Subject: Comments on Recently Received Documents Pertaining to
Seattle Tacoma International Airport Project
Third Runway - Low Flow Analysis

GeoSyntec Consultants (GeoSyntec) has been retained on behalf of the Airport Communities Coalition (ACC) to provide a technical review of investigation, analysis and design relating to geotechnical and hydrogeological elements of the proposed Third Runway Expansion Project at the Seattle Tacoma International Airport. GeoSyntec has previously commented on seismic and geotechnical aspects of the embankment fill and Mechanically Stabilized Earth Wall. In my October 2001 declaration in support of ACC's motion for stay, I raised numerous concerns relating to the Port's Low Flow Analysis. This letter presents an expansion on the issues raised in the declaration based largely on review of the November 27, 2001 report by Pacific Groundwater Group (PGG) titled "Port of Seattle - Sea-Tac Third Runway - Embankment Fill Modeling in Support of Low Streamflow Analysis."

Figure 1 - SeaTac Embankment Fill Grain Size Analysis

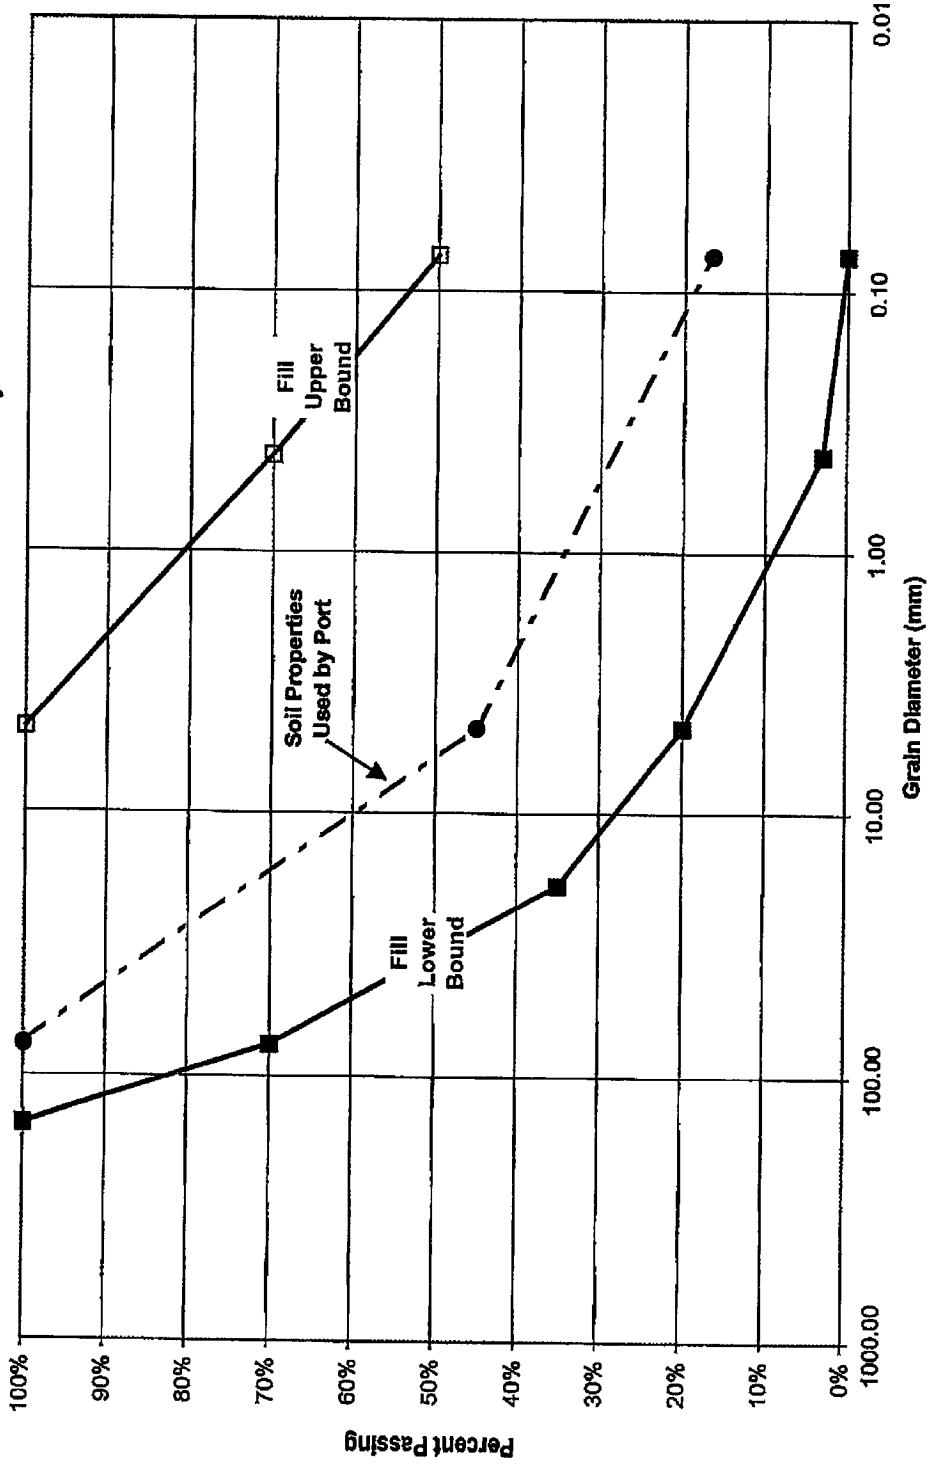
Comment 2: The analysis relies on a single set of soil parameters to represent the behavior of 20 million cubic yards of fill that will be obtained from numerous different borrow sources. This is a gross oversimplification and will lead to significant discrepancies between the predicted streamflows and those that would actually occur after construction.

The attached Figure 1 presents the range of soil grain sizes allowed by the project specifications and presents the single grain size representation used in the low flow analyses. Fill placement during construction of the embankment will occur in horizontal layers. As a result, there will likely be large areas of fill with fine-grained, low hydraulic conductivity material which will control the rate at which water flows vertically through the embankment. The overall hydraulic conductivity of the actual soil in the embankment could be several orders of magnitude less than that assumed for the current low flow analyses. This difference in hydraulic conductivity will have a substantial effect on the predictions made in the current analyses.

Figure 2a: Van Genuchten Parameter Variability

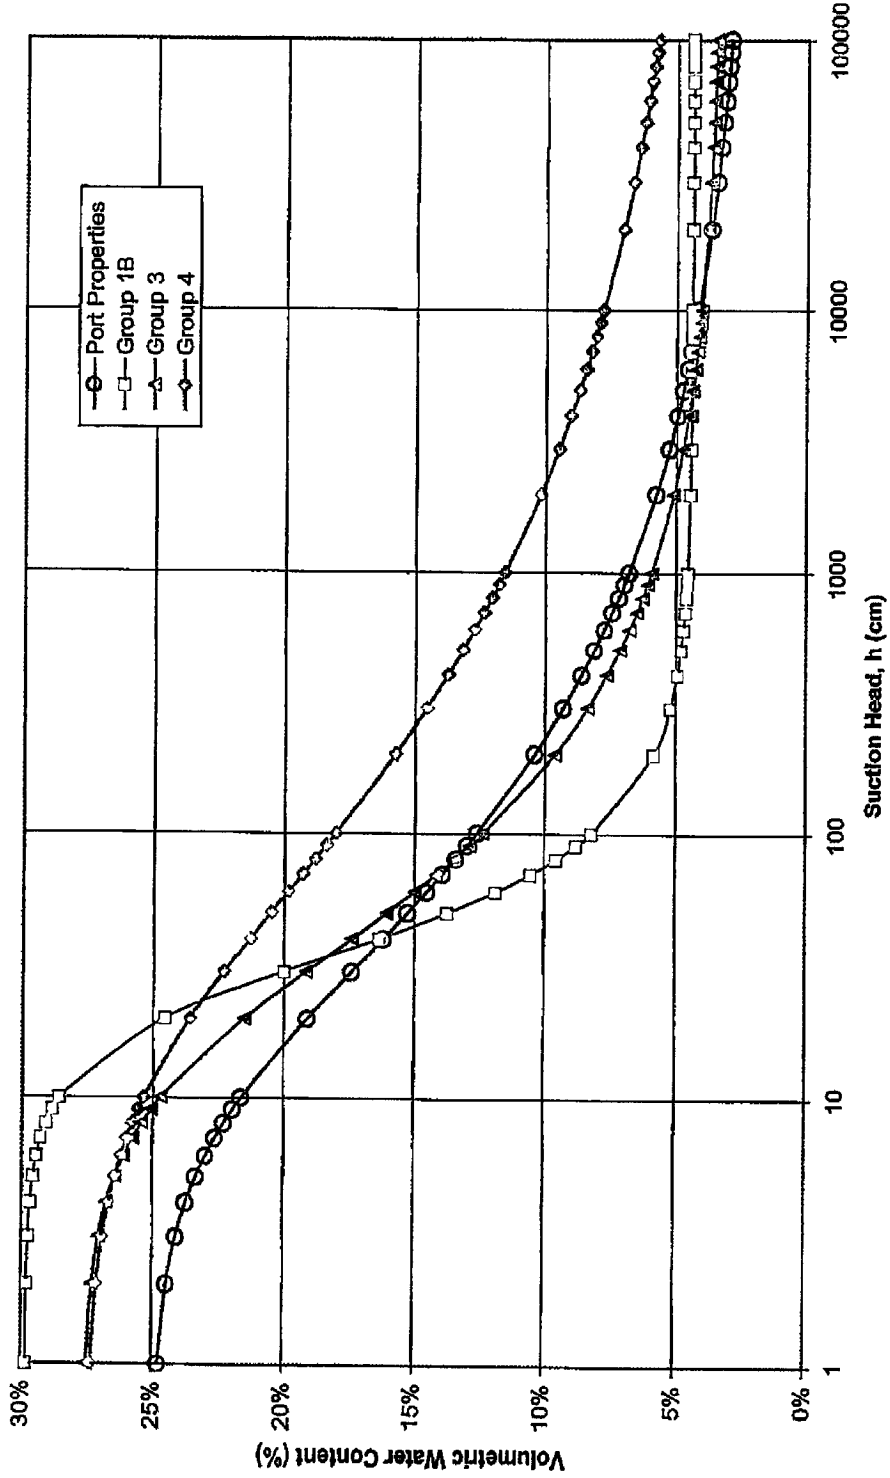
In Hart Crowser's "Embankment Infiltration and Seepage Studies" report², they presented unsaturated flow parameters and corresponding unsaturated behavior curves for three of the fill types proposed for the embankment (Group 1B, Group 3, and Group 4). Figures 2a and 2b present the representative curves developed by Hart Crowser for the three fill types, along with the single set of curves being used presently by PGG in their Hydrus modeling (labeled "Port Properties"). While Hart Crowser's modeling with the HELP program was overly simplistic and their method of accounting for gravel content was not well validated, their performance of parametric studies on the fill types was a step in the right direction compared to the single fill type currently being modeled in Hydrus. The Hart Crowser properties show that the hydraulic conductivity (which controls the rate at which water will pass through the fill) can range over several orders of magnitude for soils likely to be placed in the embankment. The figures clearly show that the single curve being used by the Port is not representative of the potential range of behavior.

Figure 3: 1-Dimensional Column Initial Lag Times for Infiltration to Reach Drainage Layer under Varying Soil Properties and Column Heights

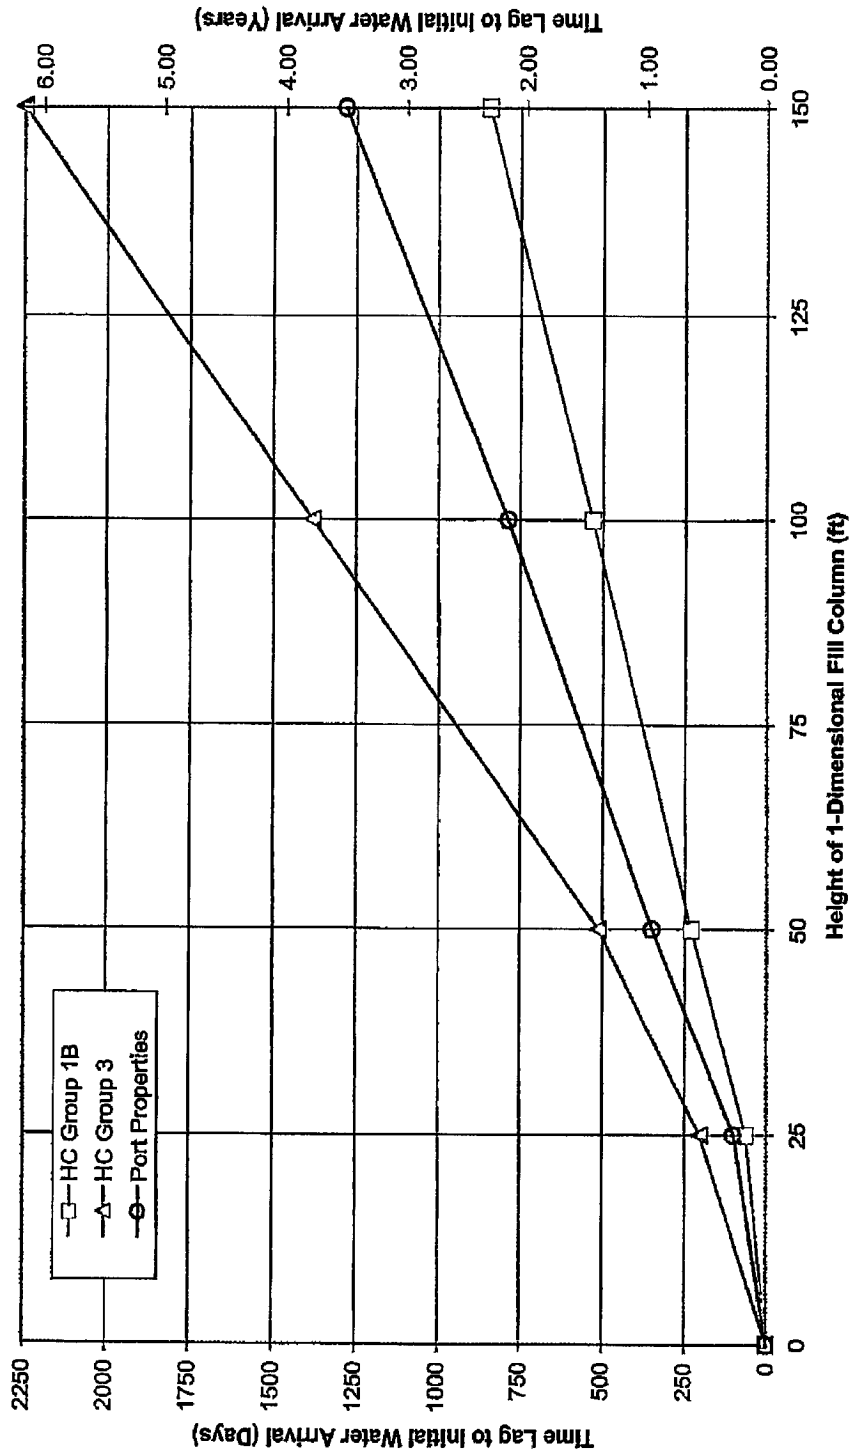
In order to demonstrate the influence of the variability of soil properties on the lag time between embankment construction and first arrival of water at the drain, several simple cases were analyzed. 1-Dimensional columns of varying fill thickness (25 ft, 50 ft, 100 ft, and 150 ft) were modeled using Hydrus for three different sets of fill properties (Hart Crowser Group 1B, Hart Crowser Group 3, and the Port Properties). The 1-Dimensional columns were modeled in a fashion similar to the Port's analyses, where all infiltration was assumed to travel vertically through the fill, without an allowance for horizontal flow. Figure 3 shows the results of these analyses. A curve is shown for each set of properties, immediately revealing the potential for variability in the results. Each point on the curves represents the time between the beginning of the analysis (Day 0) when the precipitation record begins, and the time when the first water reaches the drain at the base of the column. As the height of the 1-Dimensional column is increased (i.e. as the embankment fill thickness increases) the time lag increases relative to the properties for each fill type. For example, for a 50 ft fill thickness, the range of time lags shown is 250 to 500 days (approximately 0.7 to 1.4 years), and for a 150 ft fill thickness, the range is 850 to 2250 days (approximately 2.3 to 6.2 years). It will be shown later that ignoring the horizontal flow component in the fill (i.e. performing a 1-Dimensional analysis) results in an overestimation of the rate at which water flows through the fill, and thus the predicted lag times will actually be even longer than these values. In any case, the differences clearly demonstrate the potential variability in results which the port is ignoring in their analyses. Incorporation of this type of

Figure 4a: Current Model System, all flow travels vertically through sand & silt matrix

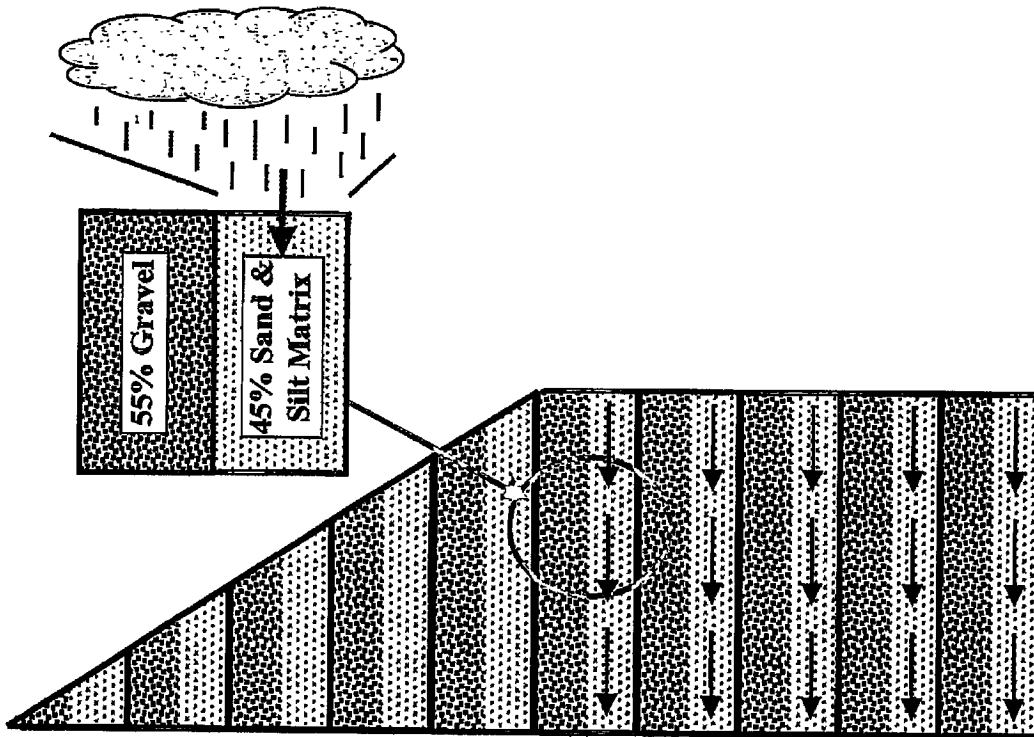
Comment 4: The Port's method of modeling of flow through the fill as a 1-Dimensional phenomenon using Hydrus is an oversimplification of a truly 3-Dimensional process, and will result in an overprediction of the rate at which water travels through the embankment.

In addition to the Port's ignoring the gravel content of the embankment fill, their analysis consists of a series of 1-Dimensional columns of soil of varying thickness which force the infiltrating water to travel downward unimpeded without any lateral migration. Figure 4a shows a schematic of the system the port is actually modeling. Each column theoretically consists of 55% gravel and 45% sand and silt. However, water falling on any given column of soil is forced through the sand and silt matrix (achieved through artificial adjustment of precipitation and discharge quantities), bypassing the gravel completely. It should also be noted that water falling on the sloping face of the embankment is assumed not to infiltrate at all, and because the water can only travel vertically, this region never sees any water at all.

Figure 4b: More realistic scenario, flow paths change continuously throughout profile

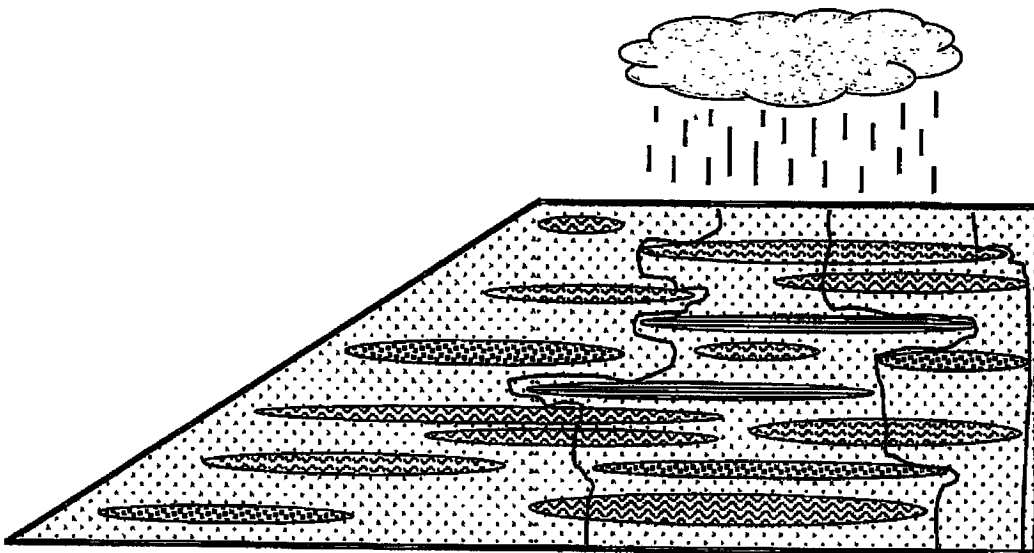
Figure 4b shows a schematic (which is still a simplification) of the type of layering that will exist in the embankment fill as a result of the construction process. 20,000,000 cubic yards of fill will be imported from numerous borrow sources and placed in horizontal layers at the then current elevation. The soil layers with the lowest hydraulic conductivity will control the vertical rate of flow of water traveling through the embankment. It will be impossible for the Port to control the fill sufficiently that an assumption of uniform flow behavior can be assumed realistically. The Port has failed to consider the very real variability of the soils that will be placed in the embankment. As a result of the fill layering, the flow path will be significantly more complex than

represented by the Port (e.g. Figure 4a), and the time for water to travel through the embankment will be much slower than predicted.

Figure 5: Moisture Content Variation Over Time for Cross Section 2
Using Hart Crowser Group 3 Embankment Fill Properties

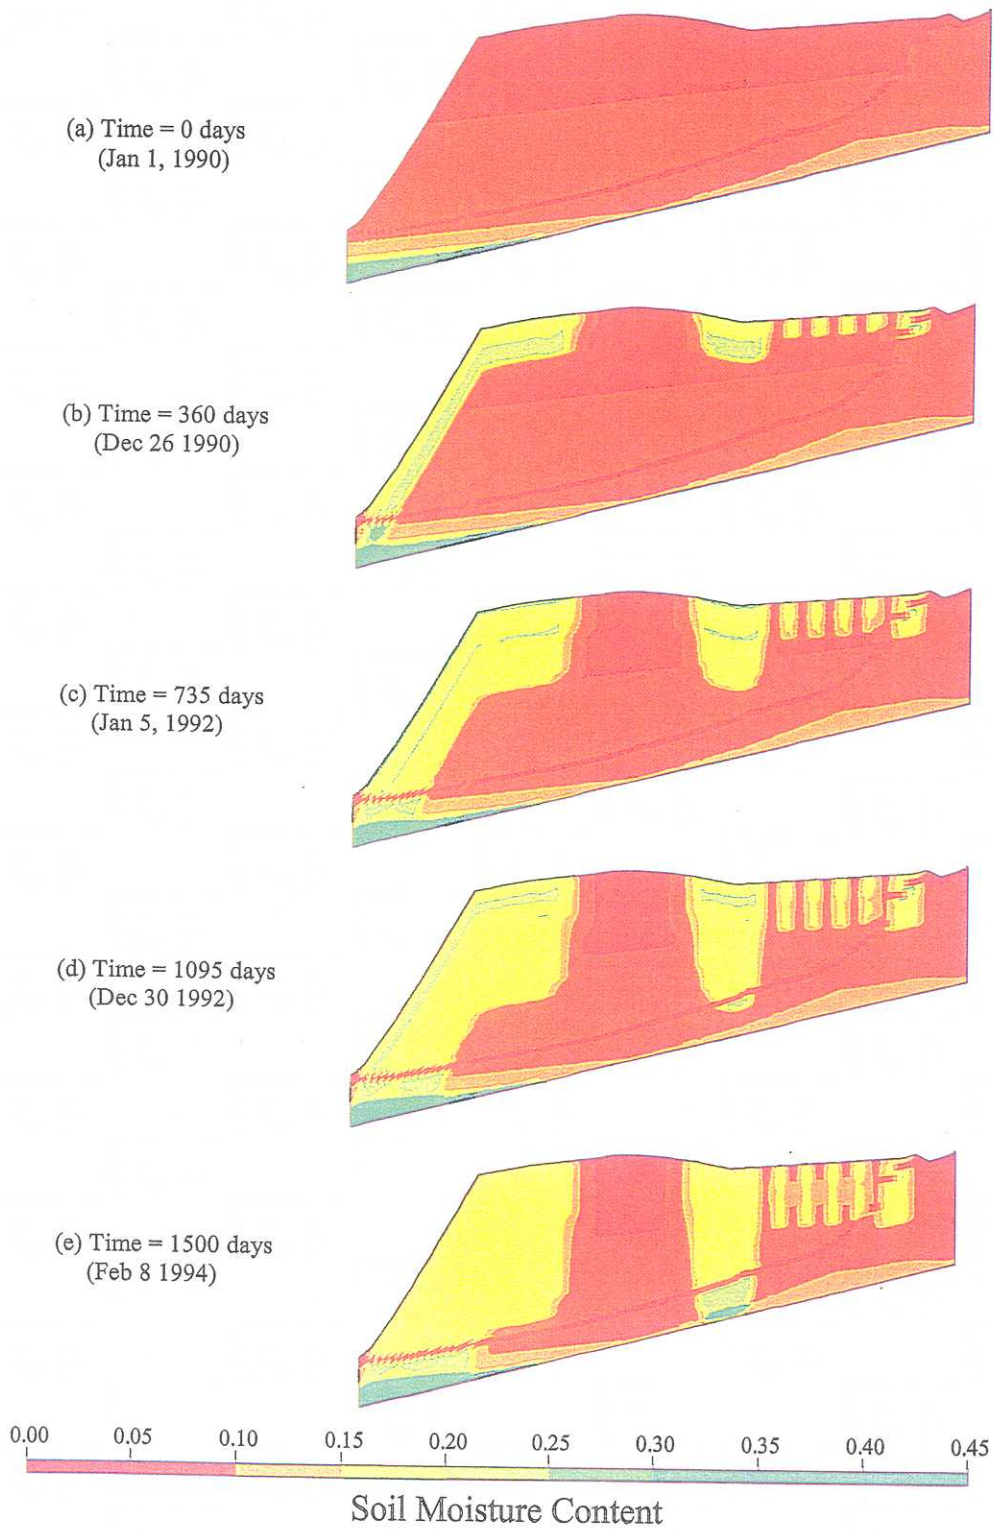
Figure 5a presents a schematic of the Hydrus model cross-section being used by GeoSyntec, which is based on PGG's section 2, with an embankment fill height of up to 110 ft. The embankment fill, the drainage layer, the outwash layer, and the underlying till are all being modeled within Hydrus. The model is being run using approximately four years of daily precipitation data (January 1990 through February 1995) from the SeaTac airport. No runoff or evapotranspiration calculation has been made, so all precipitation is assumed to enter the embankment.

Figures 5a through 5e present preliminary results using the Hart Crowser Group 3 fill properties described in Comment 2. The lighter colored front that progresses downward over time represents the propagation of the infiltrating precipitation. It is clear that the water infiltrating near the face of the slope, which has a shorter travel path to the drainage layer has already begun to reach the drain and then the creek by approximately 1 year after the modeling begins (Figure 5b). However, the flow under the thick majority of the embankment is only beginning to reach the drainage layer between 3 and 4 years (Figures

5d and 5e). With the uniform soil profile assumption relied upon by the Port, there is only slight evidence of horizontal flow of water, although Figures 5b through 5e show a gradual narrowing of the dark colored band of dry soil beneath the runway, indicating that moisture is gradually working its way laterally. This effect can also be seen in the flow of water between the filter strips on the right side of the model. The significance of this lateral flow component is that water will travel within the embankment fill for longer periods of time prior to reaching the drain and the creeks than with analyses limited to vertical flow only. The Port, using their simplified analyses, has reported none of these trends.

Figure 6: Comparison of 1-Dimensional versus 2-Dimensional Flow in Uniform Fill Columns (2.5 ft thick) with Port Properties

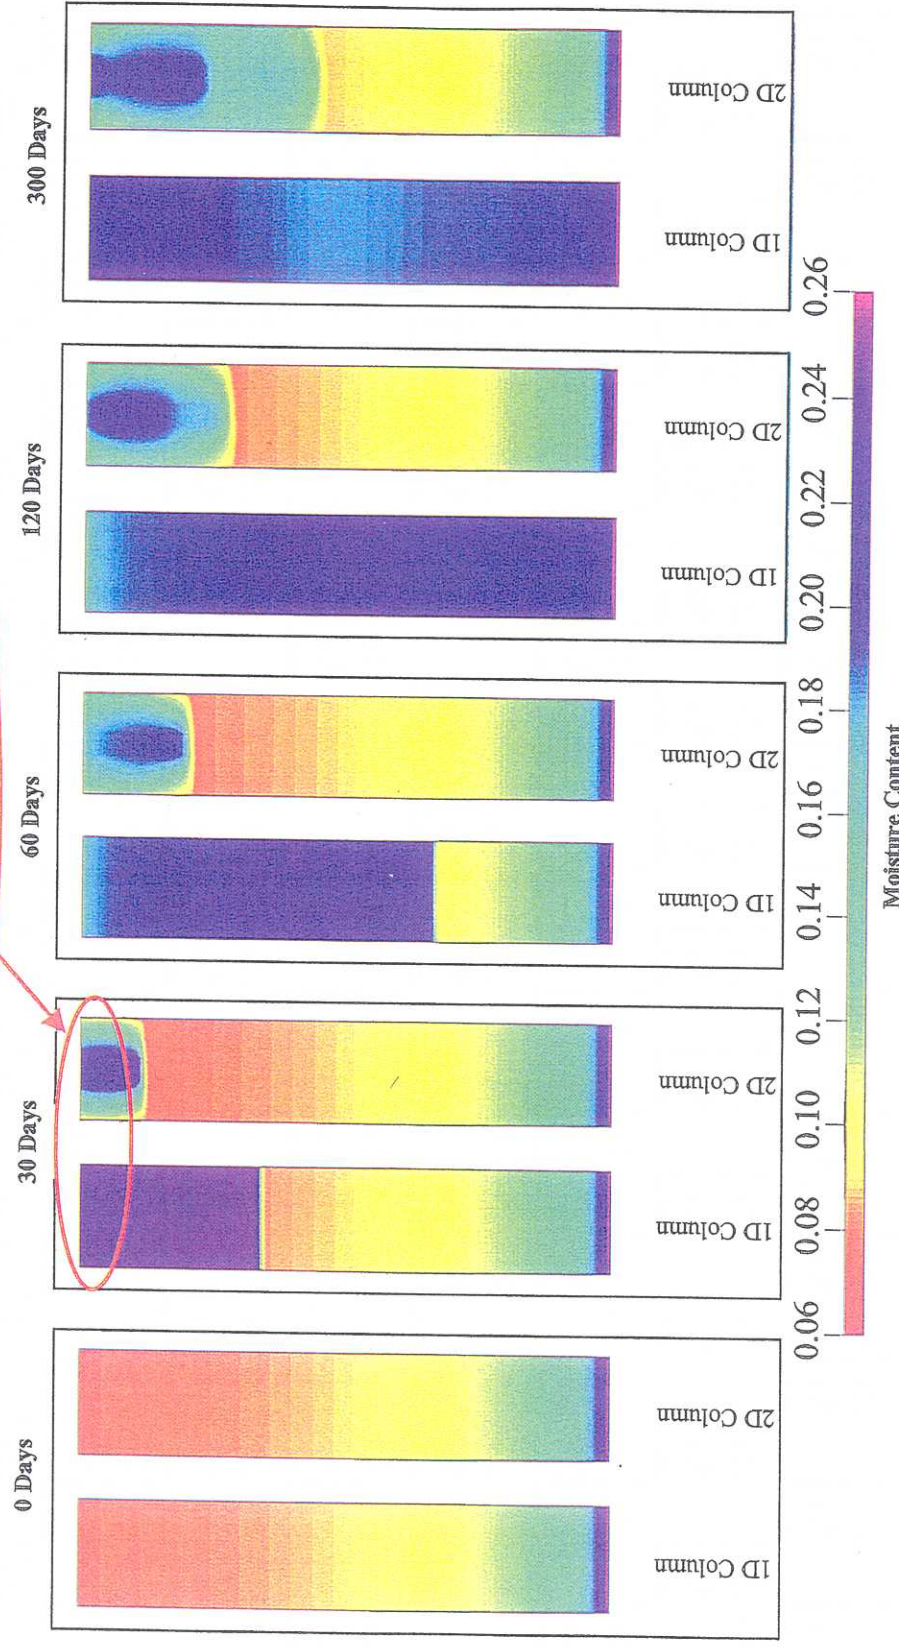
To demonstrate the impact of horizontal flow on the travel time of water flowing through the embankment, two sets of analyses were performed using the Port's soil properties as shown on Figure 6. Two 25 ft thick fill columns were modeled in Hydrus. In the 1-Dimensional (1D) column, water infiltrating at the top of the column travels downward vertically, without an opportunity for any horizontal flow (same analysis as described in Comment 2). In the 2-Dimensional (2D) column, water was applied over the middle 2/5th of the column only, but once the water entered the soil column, it was allowed to travel both vertically and horizontally. This 2-Dimensional scenario is representative of precipitation adjacent to the runway or filter strips (as seen on Figure 5), where water landing directly on the fill surface can pass directly into the embankment, but water landing on the impermeable runway or filter strips cannot.

Comparison of the 1D and 2D columns on Figure 6 makes the impact of horizontal flow immediately apparent. After 30 days, while flow in the 1D column has had nowhere to go but downwards (represented by the advancing dark colored wetting front), flow in the 2D column has traveled downwards and laterally (represented by the dark colored center and lighter colored bands spreading outwards both in front and on the sides of the wetting front). By 60 days, the wetting front in the 1D column has traveled approximately two thirds of the distance to the drain, while the 2D column wetting front has only progressed a quarter of the distance to the drain. This trend continues throughout the analysis, as the 1D column can only send water downwards, while the 2D column continues to allow water to fill in underneath the impermeable regions on either side of the entry point. Clearly, without incorporating this effect into their analysis, the Port is overpredicting the rate at which water flows through the fill, and therefore their estimates of the time at which flows will arrive at the creek will not be representative.
